NORTHVILLE DOWNS PUD FINAL SITE PLAN REVIEW

CITY OF NORTHVILLE
OCTOBER 17, 2023

CWA Review Summary: Reviewed Final Site Plan for...

Sheet L108

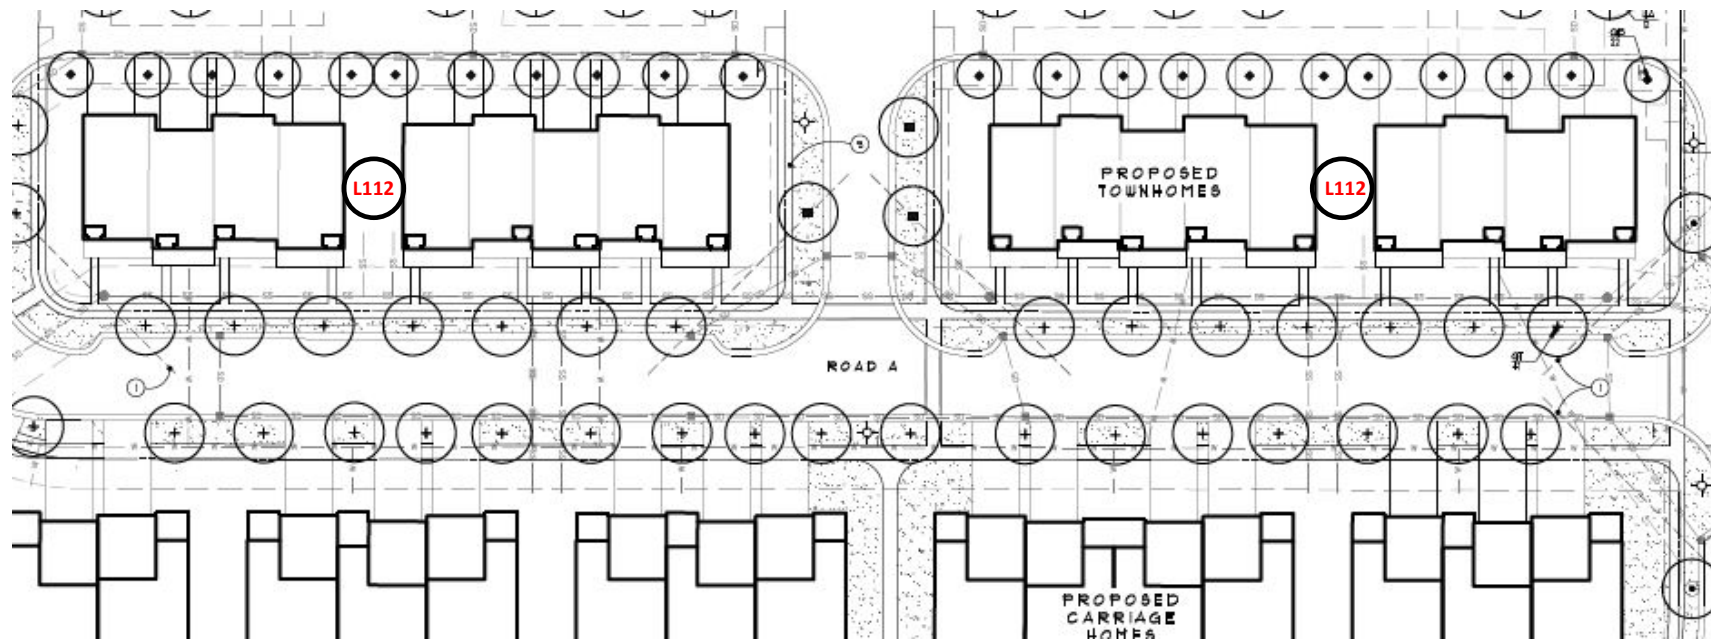
2. Screening of Vehicle Use Areas:
